COLORADO
Division of Reclamation,
Mining and Safety
Department of Natural Resources

Re: Colowyo Coal Mine (Permit No. C-1981-019)
Technical Revision No. 160 (MR-160)
Adequacy Review

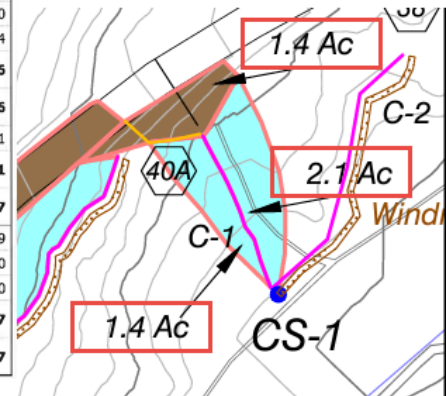
3. On proposed Figure 7-23B-1 – Section 25 Pond Watersheds During Mining, there is a 4 acre area that is not associated with any designation or curve number when reviewing the map legend. For additional reference, please see the provided figure below this comment. Please provide additional clarification for this area and ensure proper designation on the proposed Figure 7-23B-1 as well as the associated hydrology demonstration in proposed Exhibit 7, Item 23, Part B.
